**Re: Second Submission Review** – Green Valley Ranch East Site Plan No. 17 - Site Plan with Adjustment and Plat  
Application Number: **DA-1662-28**  
Case Number(s): 2022-4034-00; 2022-3032-00

On behalf of Oakwood Homes, Aztec Consultants, Dewberry Engineering and Terracina Design, we have reviewed the comments dated June 14, 2022. The following is a response to comments.

# GREEN VALLEY RANCH EAST FILING NO. 17 SITE PLAN

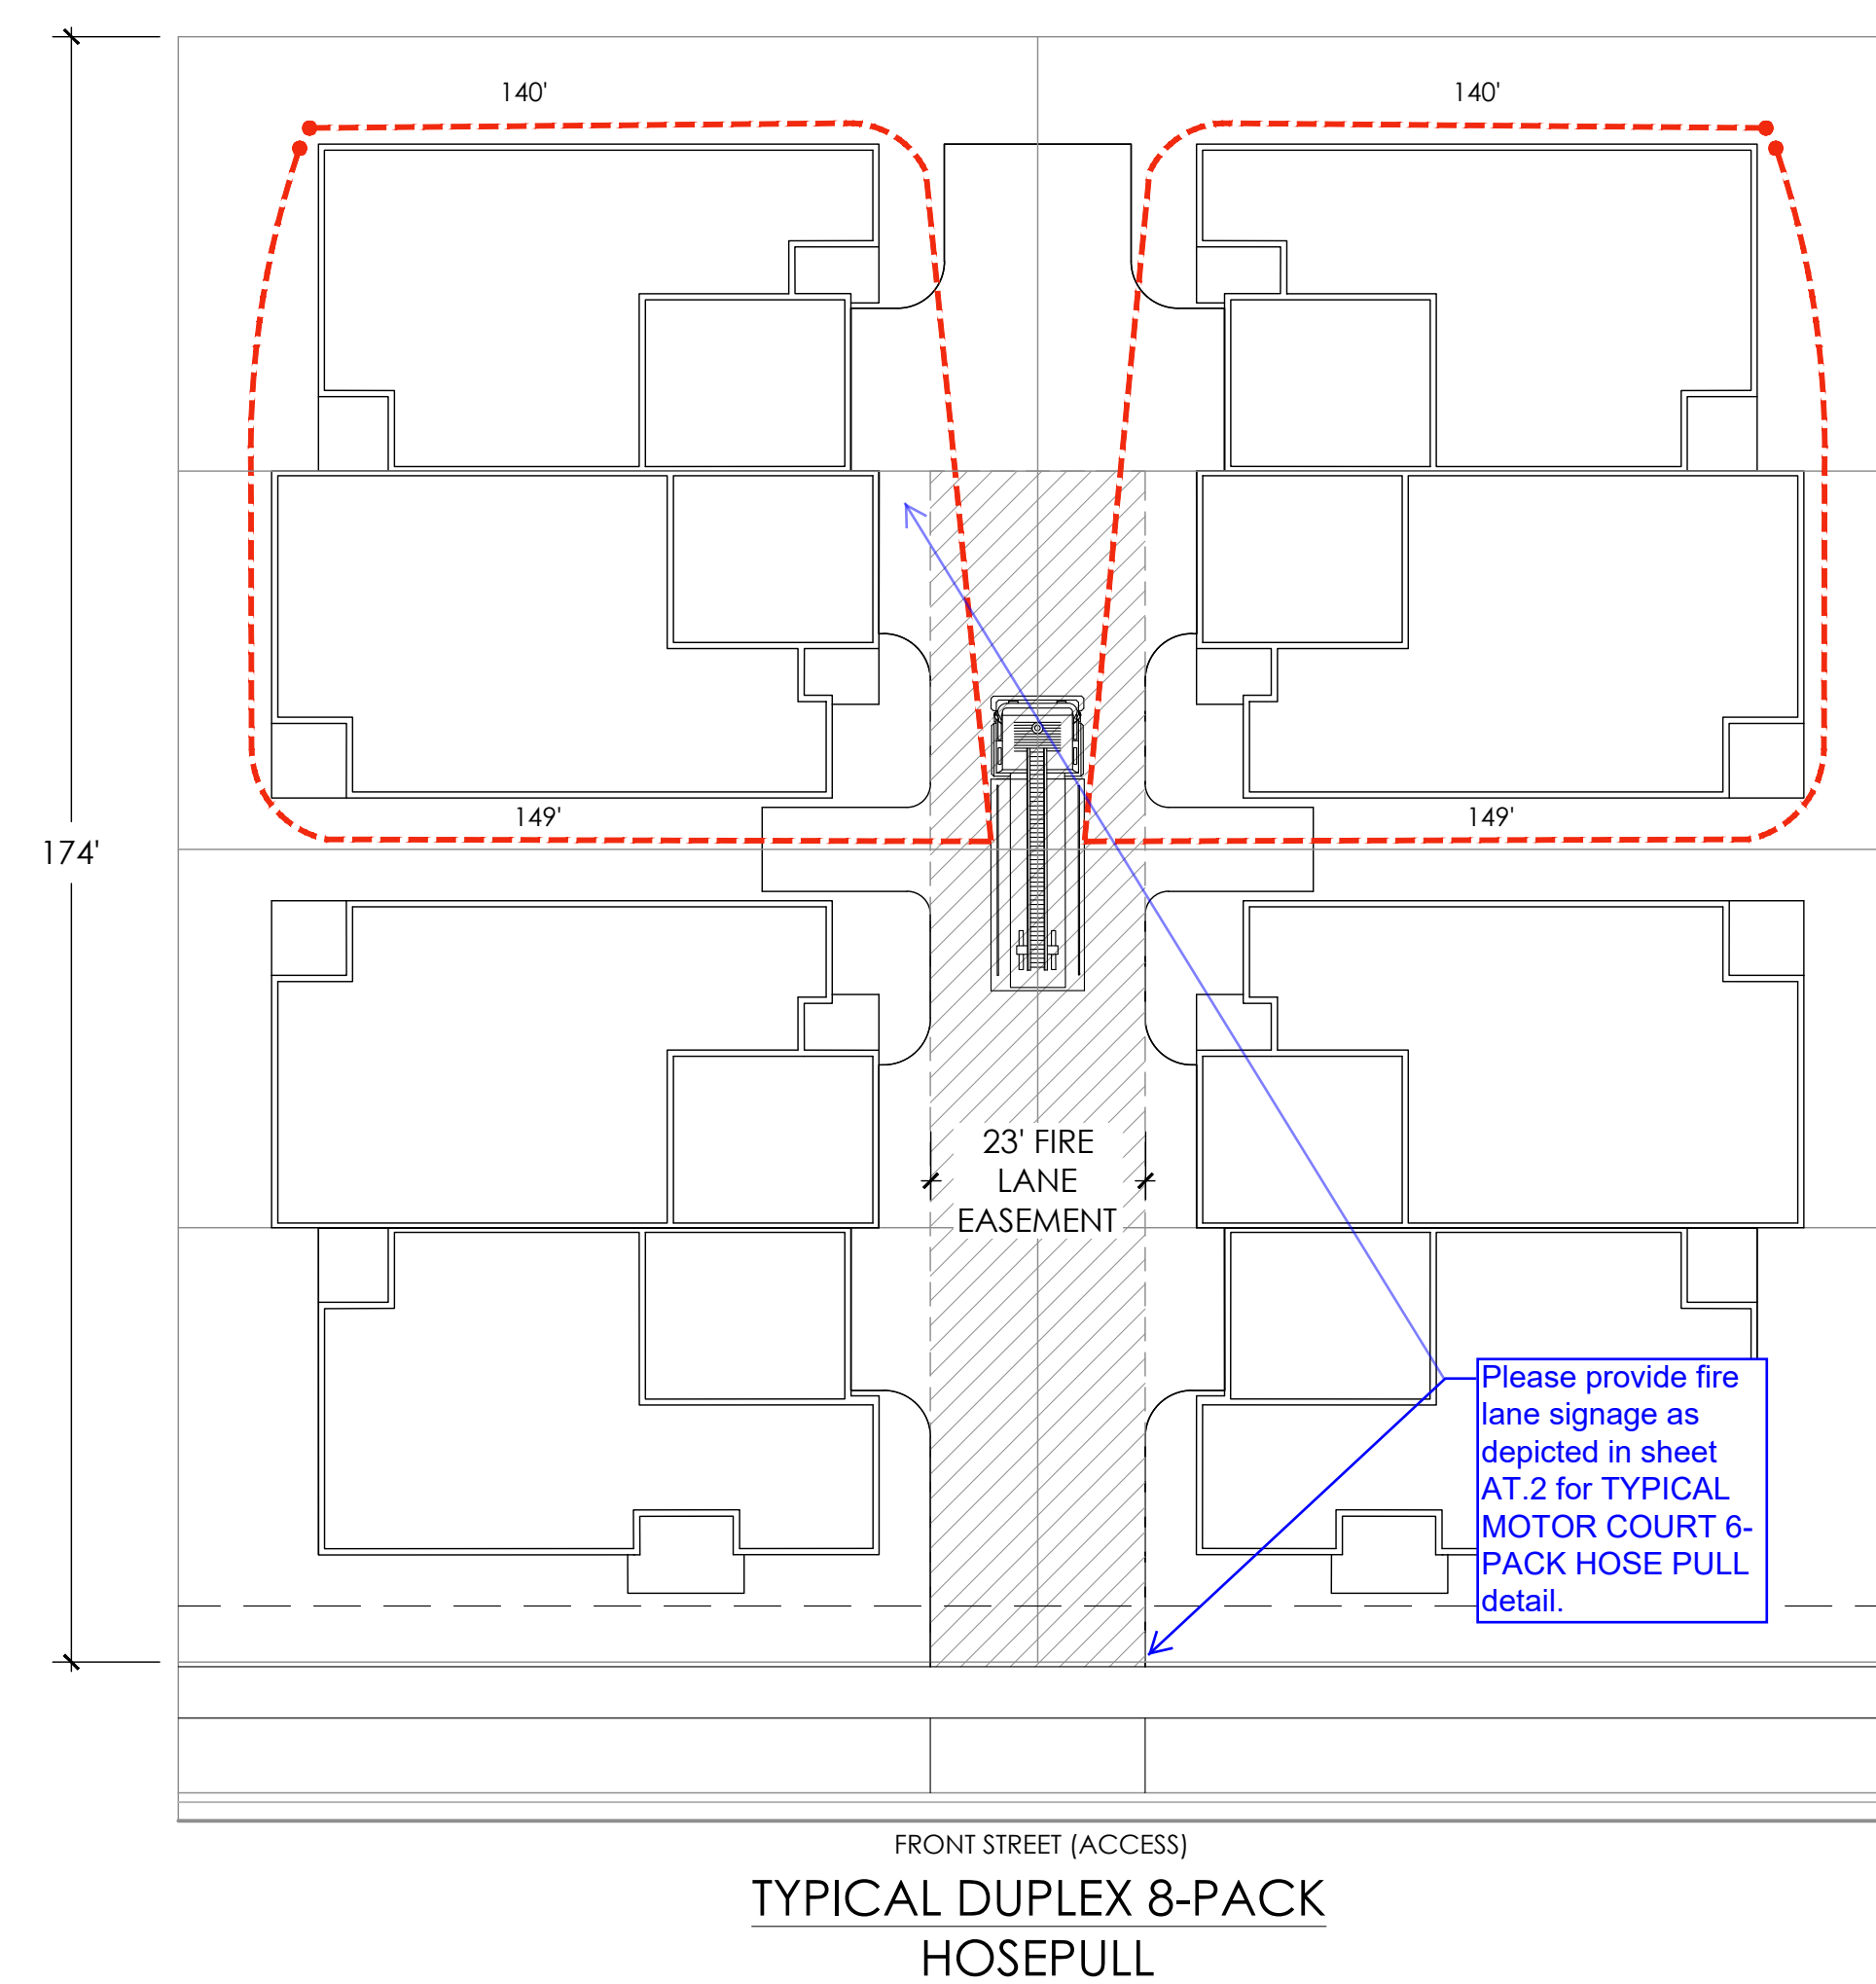
- If applicable, include a detail for duplexes on a through motor court (alley)
- Additional dimensional comments may be forthcoming if the applicant pursues duplexes on a motorcourt

That type of duplex was taken off the plan

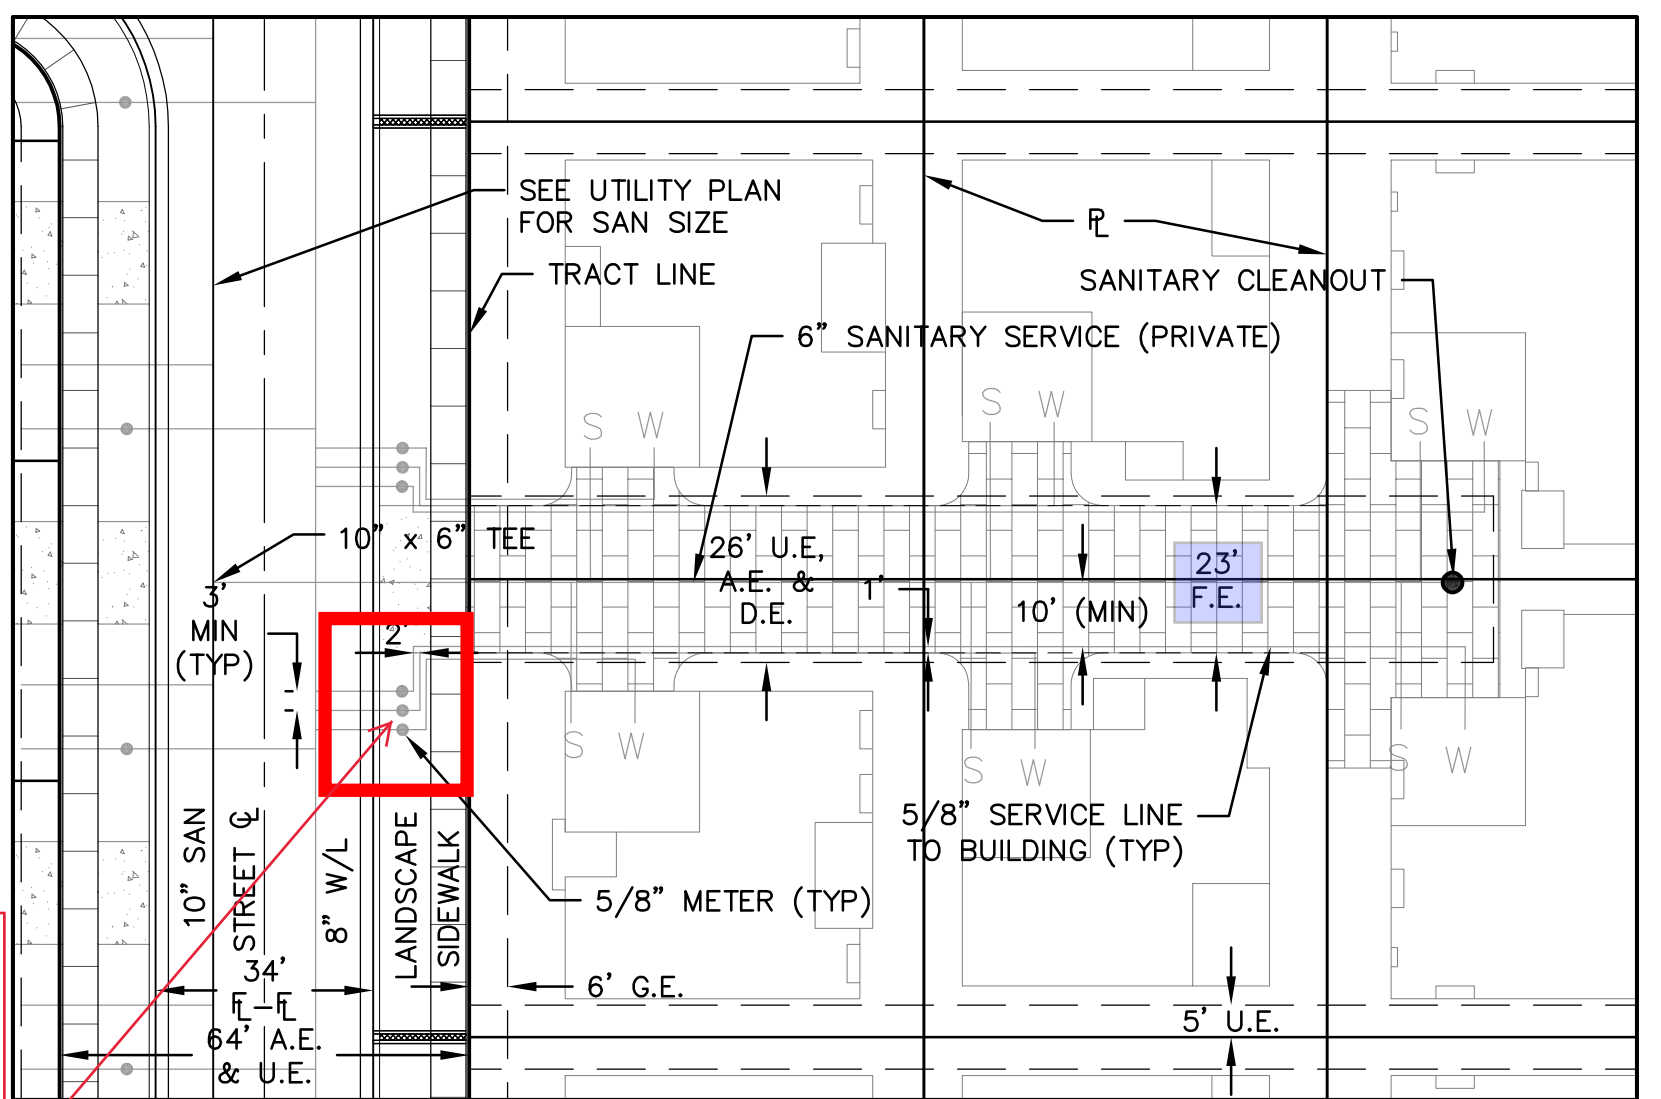
The arrow isn't pointing to a service?

Updated.

**TYPICAL SERVICES DETAIL**  
6 PACK BUNGALOW  
SCALE 1"=30"

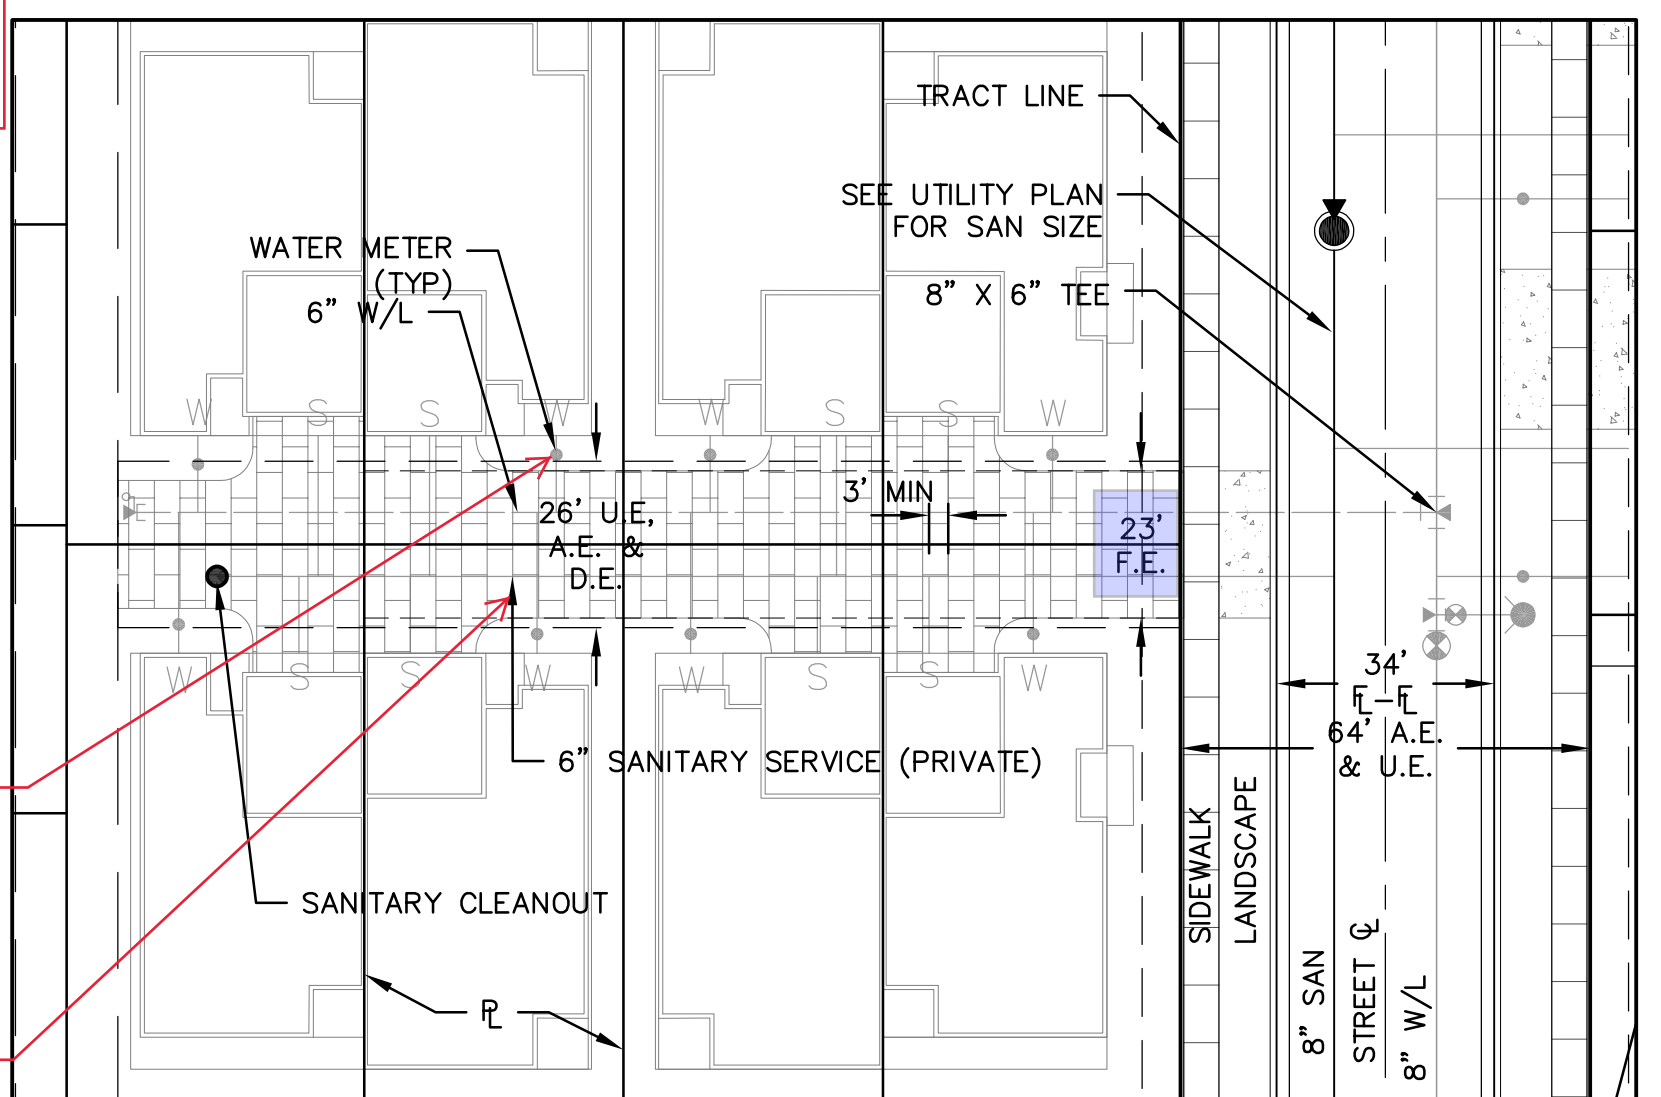
Instead of labeling all the services, include note that all sanitary sewer services and cleanouts are private-typ.

Updated.

## SITE DATA

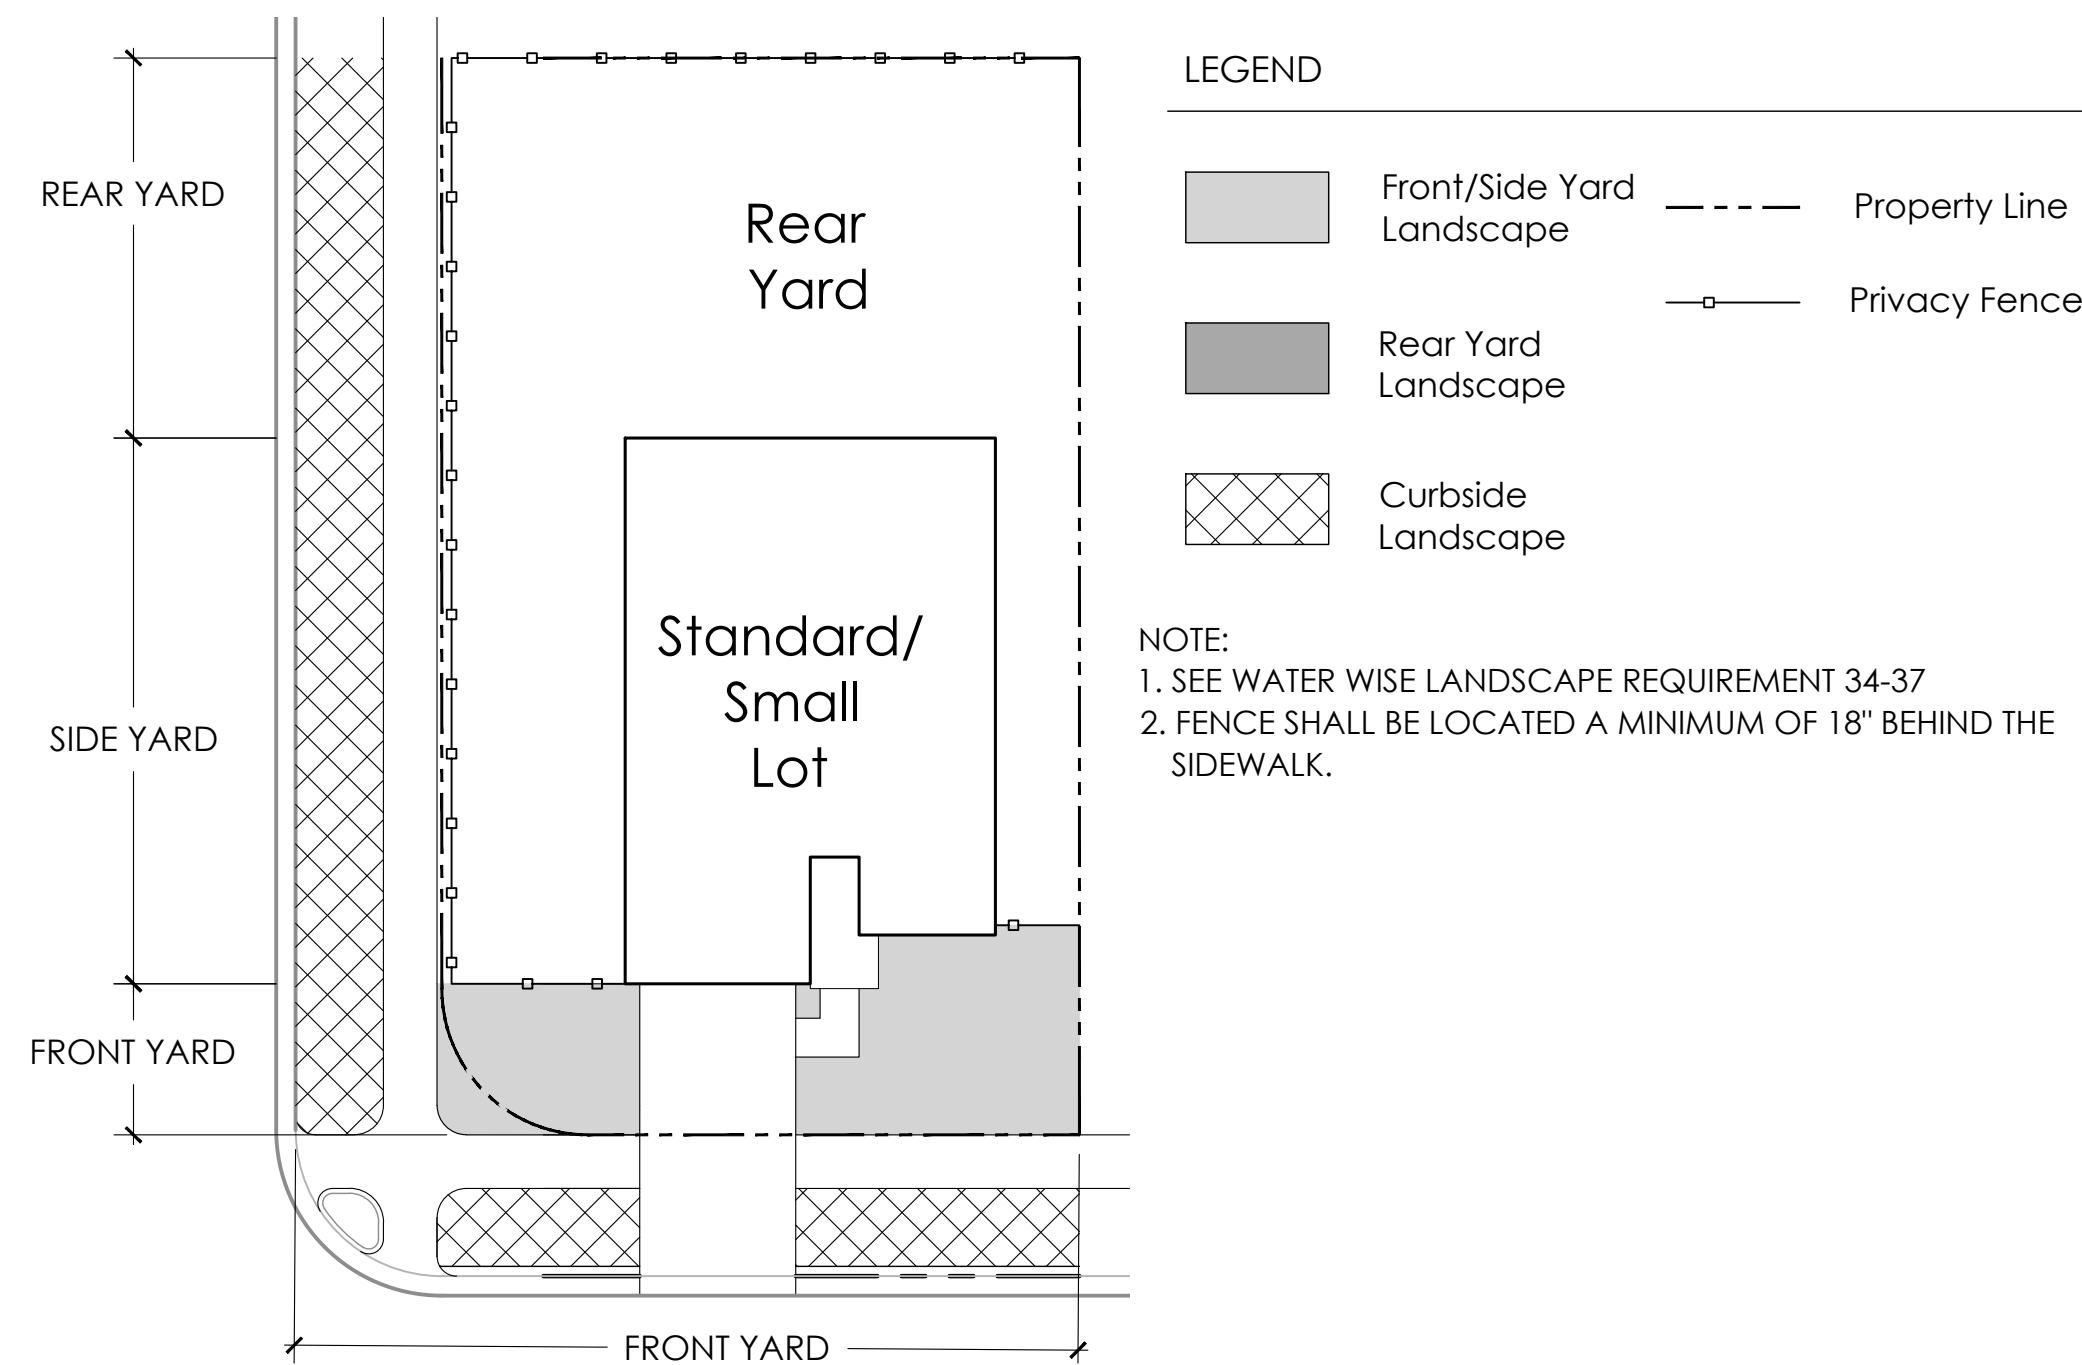
confirm perennials  
are not included in  
quantity

Revised
